ROWLANDS CREEK ROAD (MITCHELL ST – CHOWAN CK RD) TRAFFIC AND SAFETY ASSESSMENT

**JACK HALLAM
C/- JIM GLAZEBROOK & ASSOCIATES PTY LTD**

BITZIOS
consulting

Figure 3.5: Issue Location Curve 4 of 6

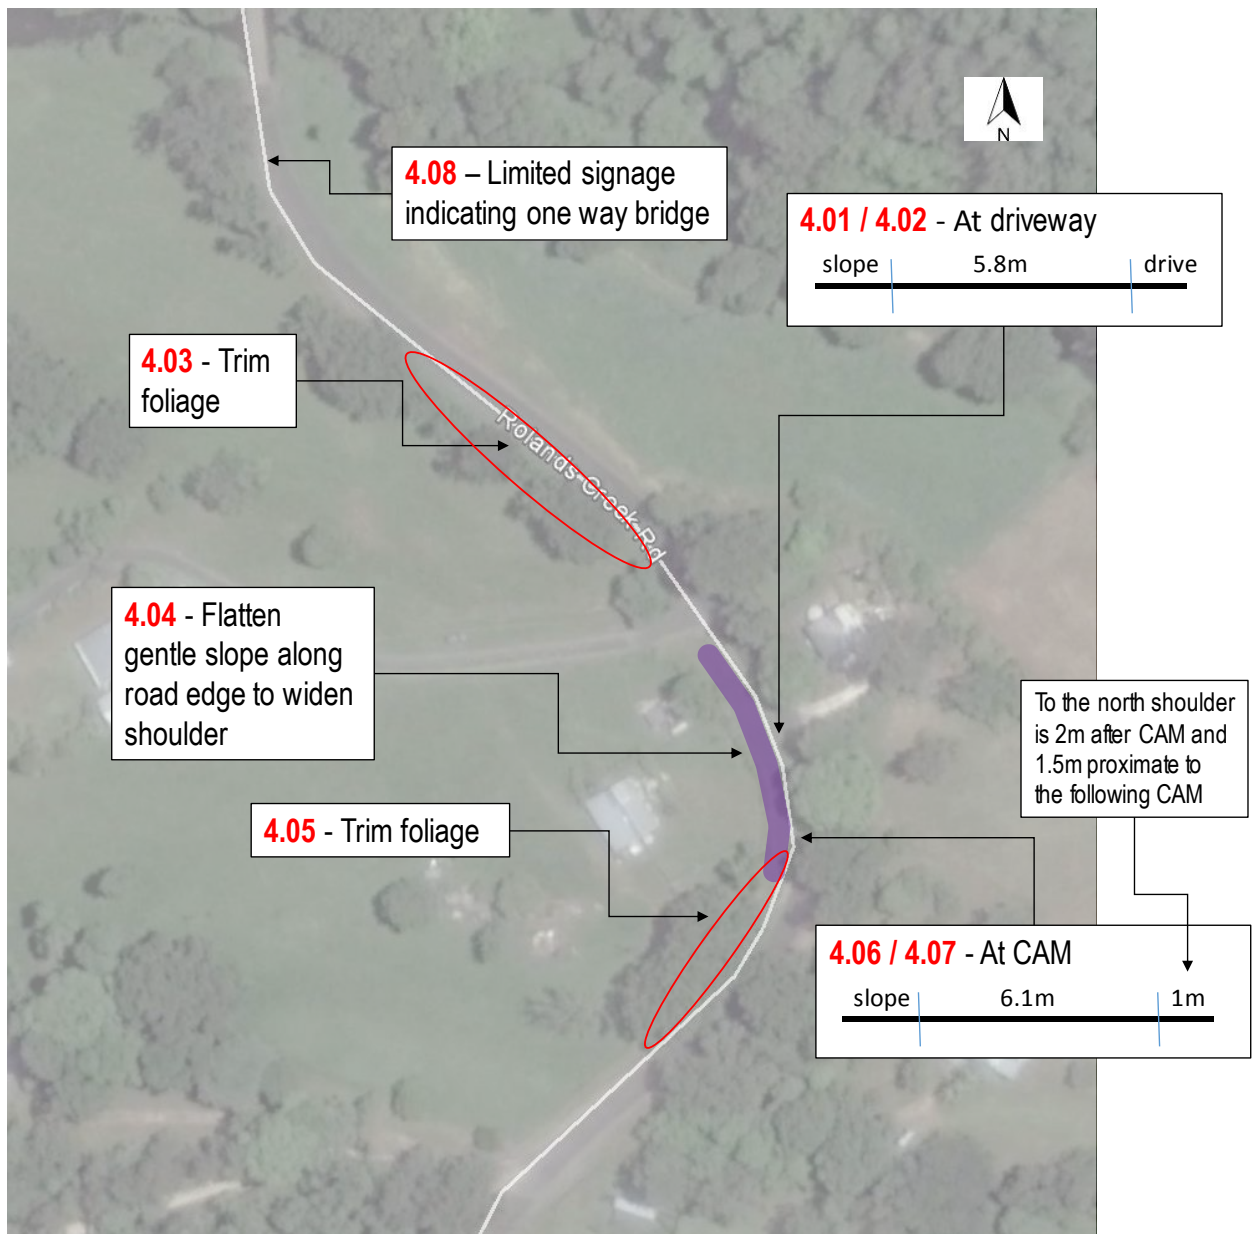
It is noted that this curve was a key concern within Council's RFI request and exists between two one-way bridges.

- sufficient roadside space is available to widen unsealed road shoulder to 1.3 metres with gravel as per Council's Standard Drawing for Class B rural road;
- trimming foliage on eastern road side would improve sight lines;
- minor civil works to flatten part of gently sloped verge along western road edge would allow a wider shoulder for passing vehicles; and
- lack of curve warning signage approaching the curve and one-way bridges to the north and south of the assessed curve.

Figure 3.6: Issue Location Curve 5 of 6

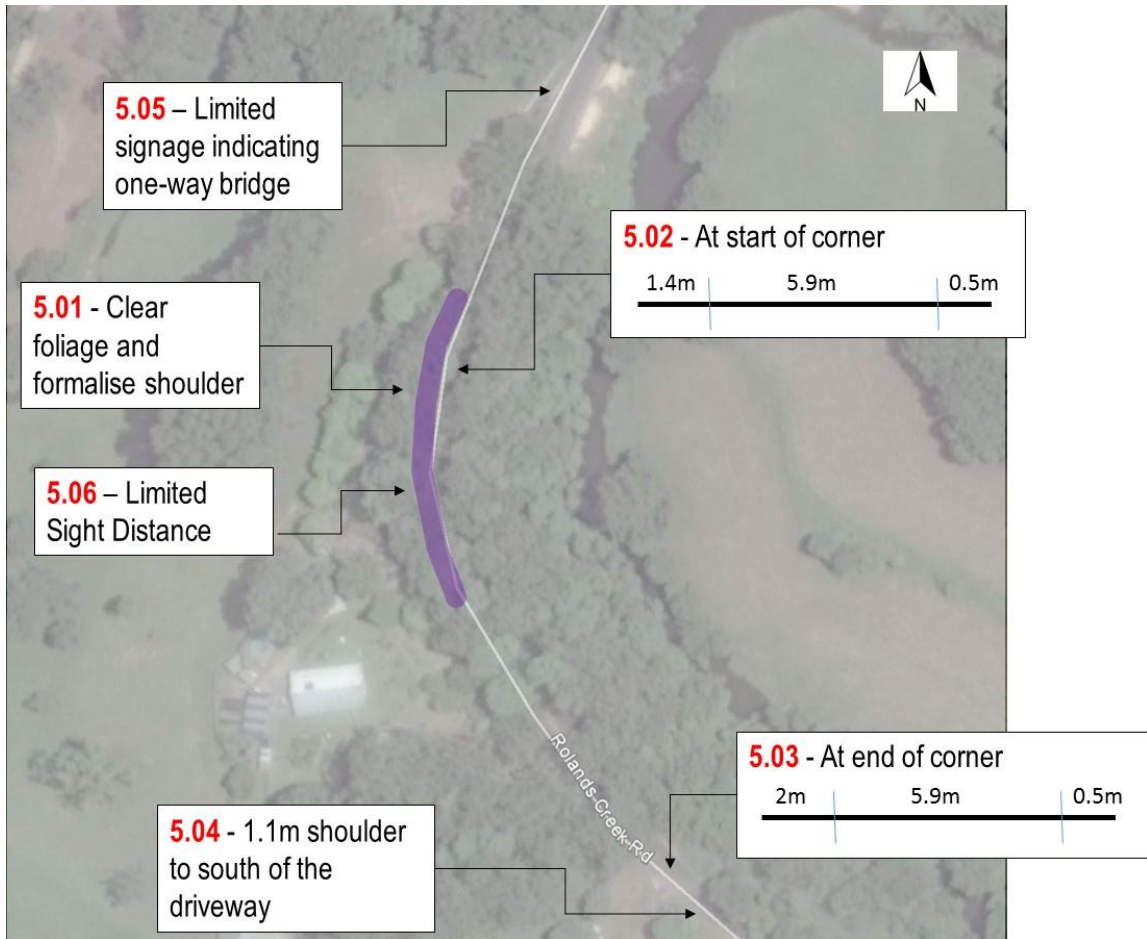
- lack of warning signage and give-way line marking on approach to the one-way bridge to the north;
- sufficient space exists along western side of road to allow for vehicles to pass however the area needs clearing of foliage and formalising;
- road cross-section is constrained near driveway at southern end of corner. Consider extending or widening driveway area to the south and west to allow for larger passing area or stopping area;
- suggest installing truck warning signage on approaches to this curve; and
- it is noted that existing major flood damage at northern end of corner effectively makes the road one-way.

Date: 15/05/17	Drawing Name: Curve 2 (Ch. 1.5km) Swept Path Assessment - Truck and Car		
Project No: P2759	Project Name: Rowlands Creek Water Extraction Traffic Services		
		Sheet 1	Version A

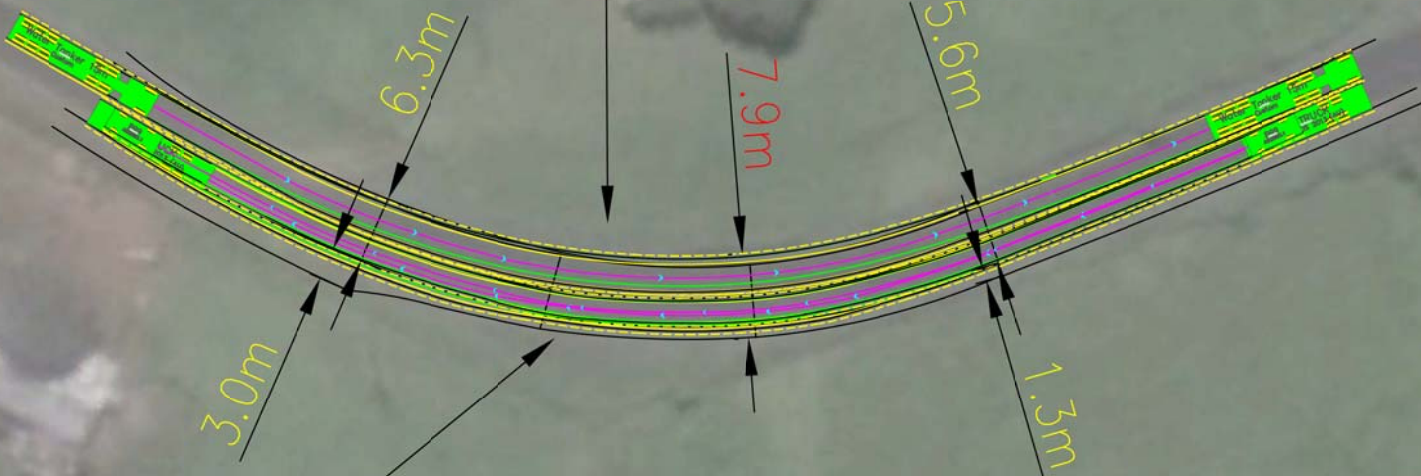
Works required to cut hill size for sight distance and road width. (Item 2.03 and 2.06)

Install truck and curve warning signage on both approaches to curve (Item 2.04)

Formalise available shoulder to improve road width. (Item 2.01)

Drawing Name:	Curve 4 (Ch.2.6km) Swept Path Assessment - Truck and Car
Project Name:	Rowlands Creek Water Extraction Traffic Services

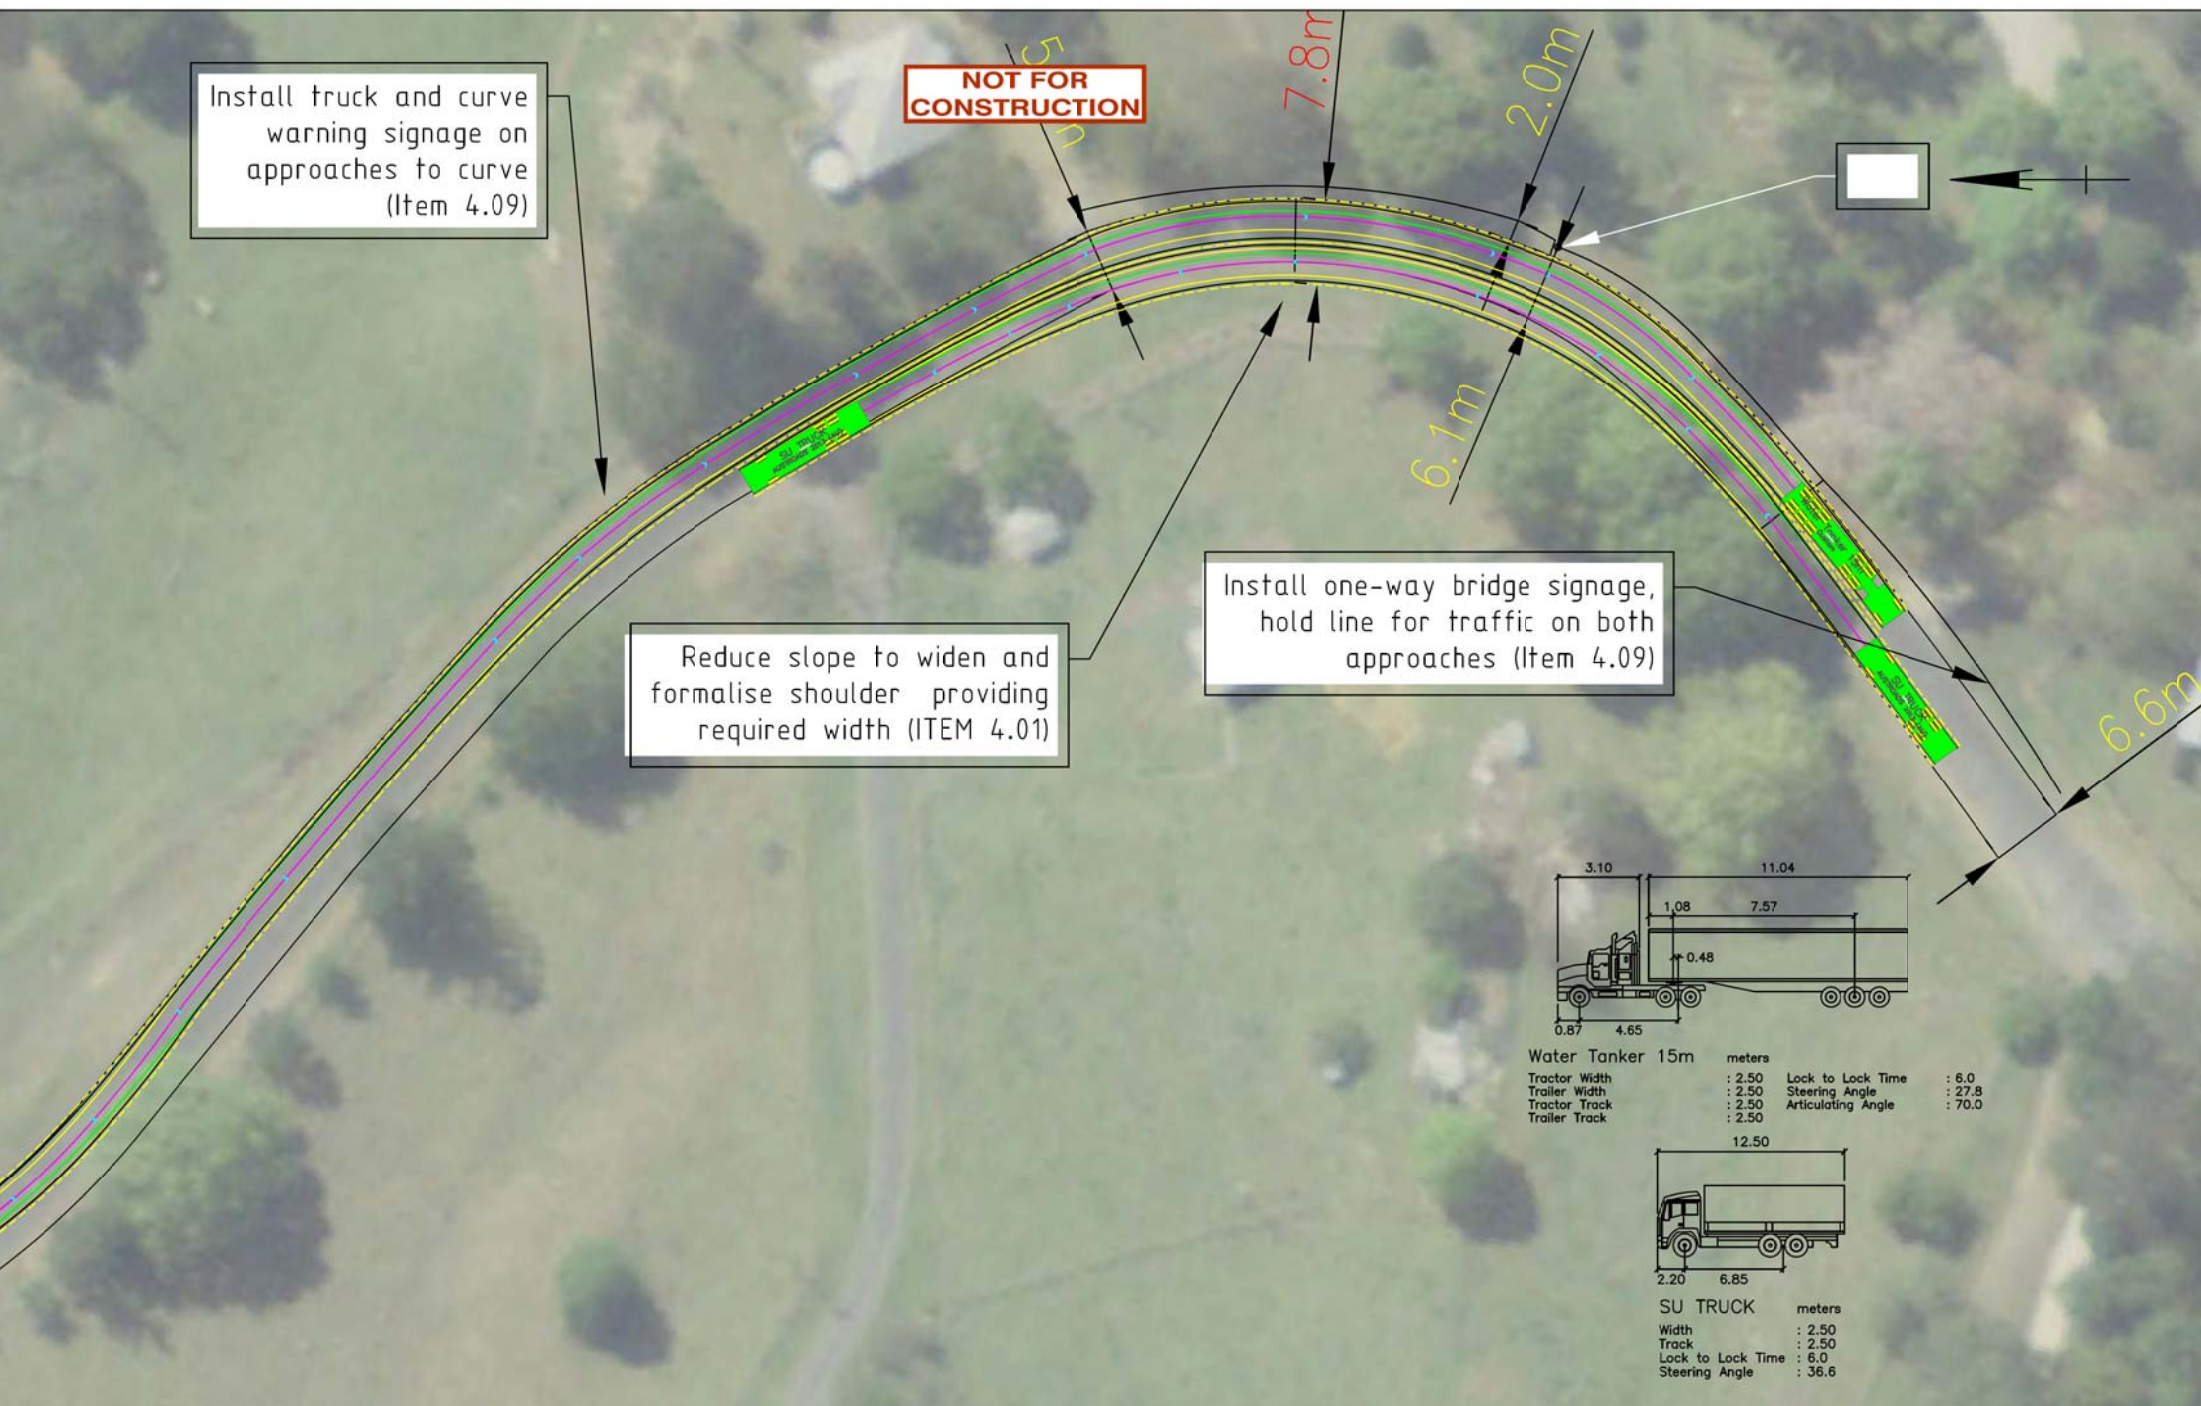
Install truck and curve warning signage on approaches to curve (Item 4.09)

Reduce slope to widen and formalise shoulder providing required width (ITEM 4.01)

Install one-way bridge signage, hold line for traffic on both approaches (Item 4.09)

Drawing Name:	Curve 5 (Ch.3.0km) Swept Path Assessment - Truck and Car
Project Name:	Rowlands Creek Water Extraction Traffic Services

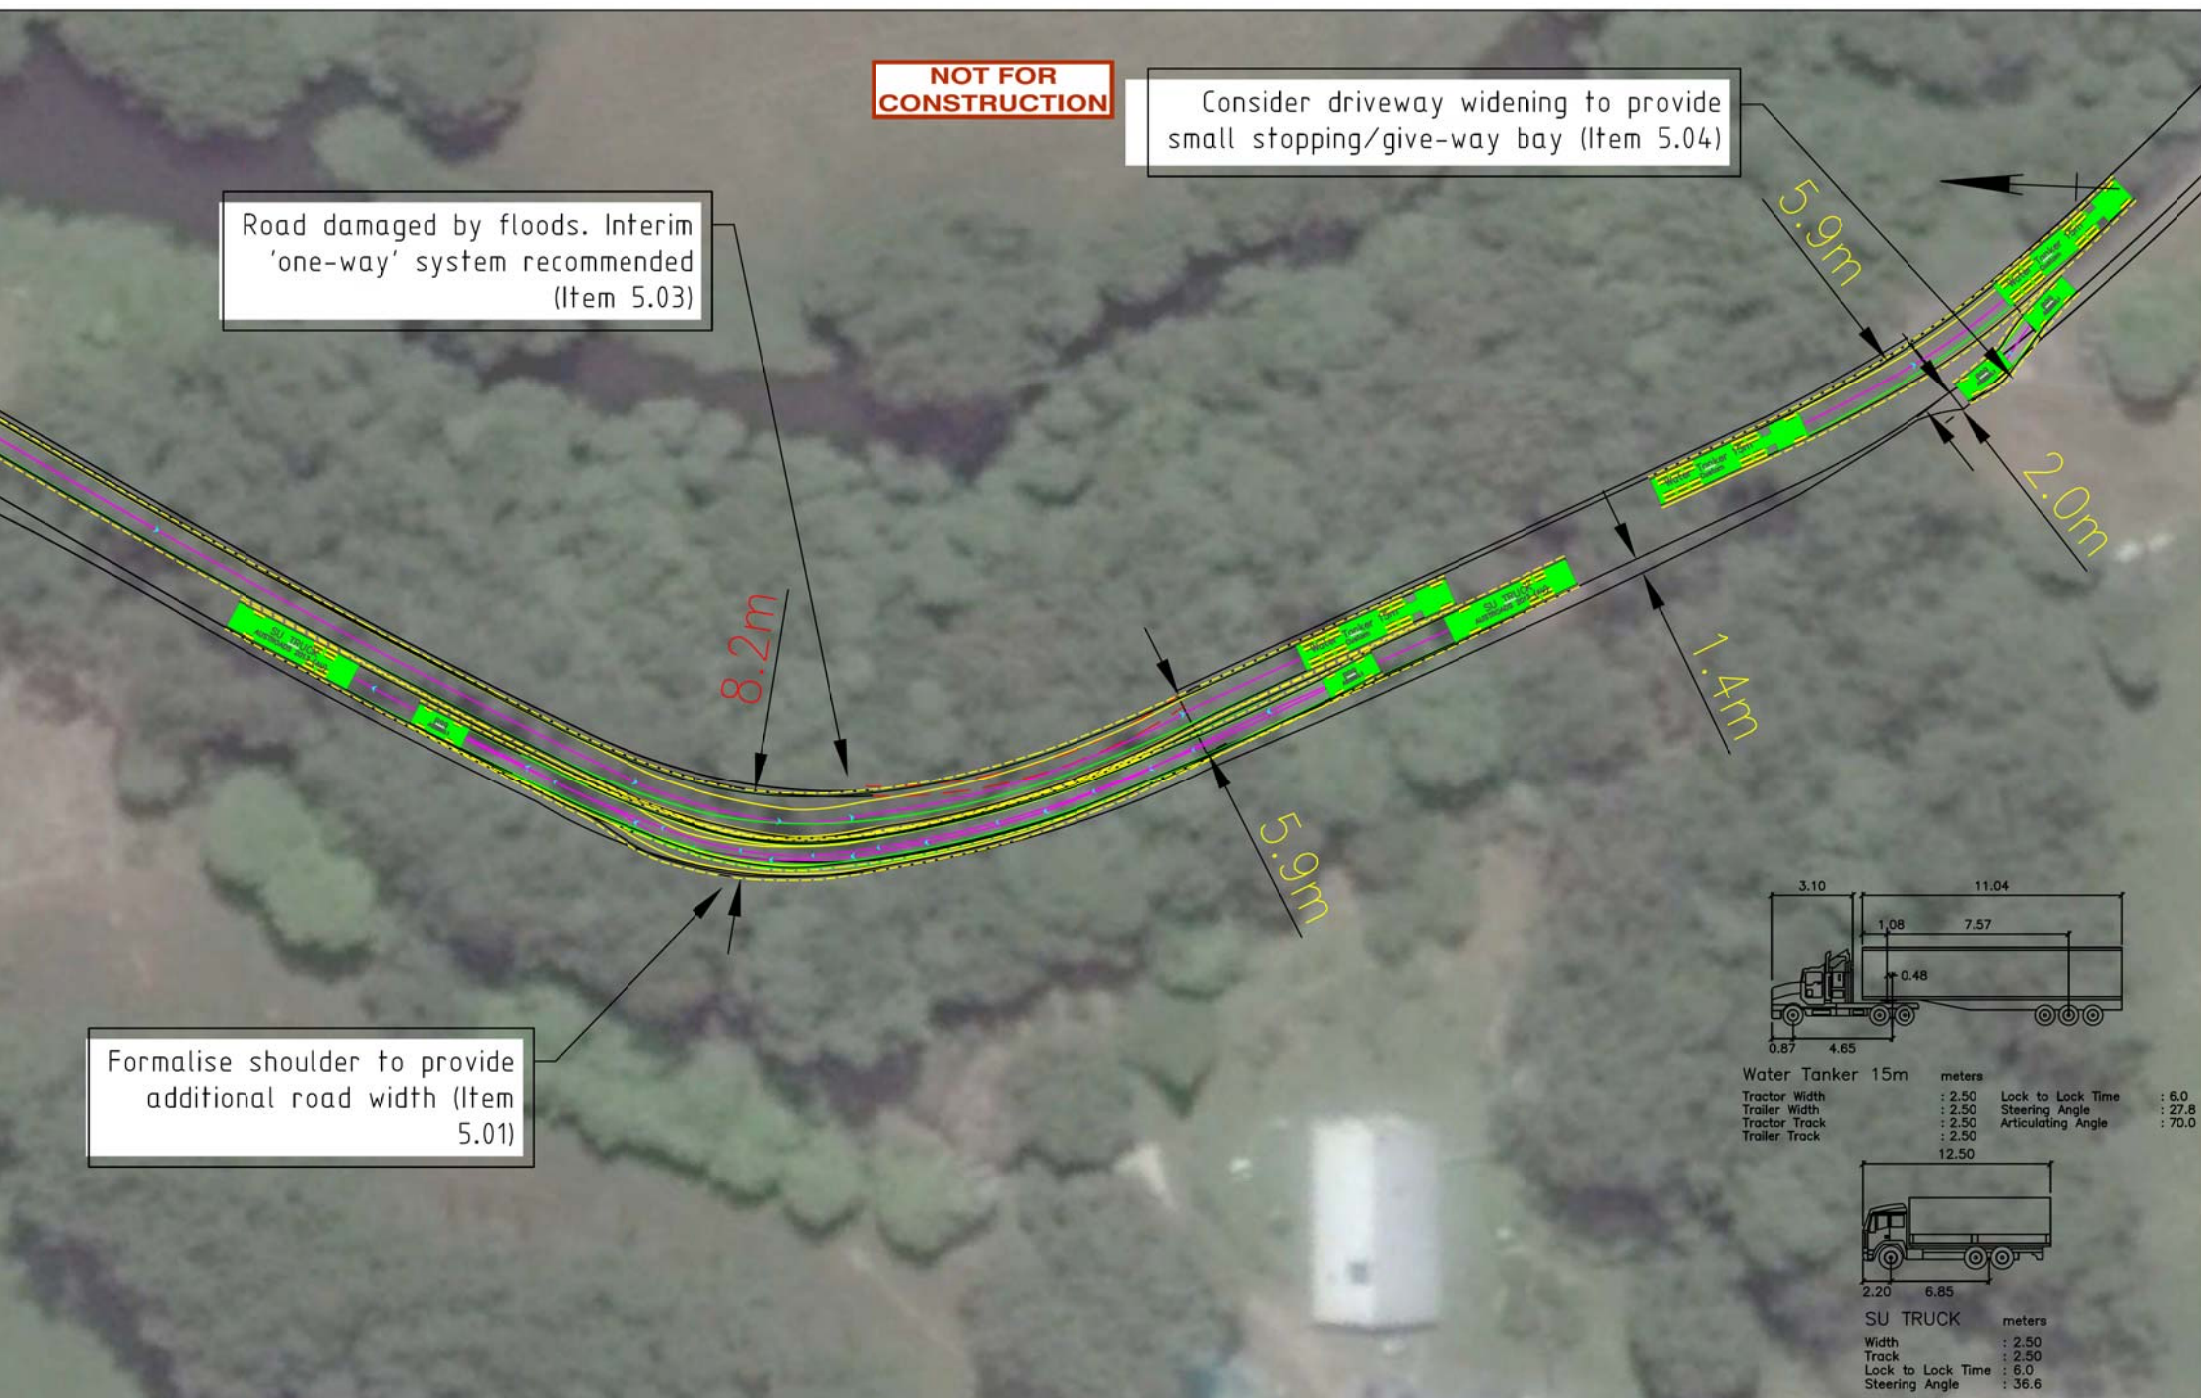
Consider driveway widening to provide small stopping/give-way bay (Item 5.04)

Road damaged by floods. Interim 'one-way' system recommended (Item 5.03)

Formalise shoulder to provide additional road width (Item 5.01)
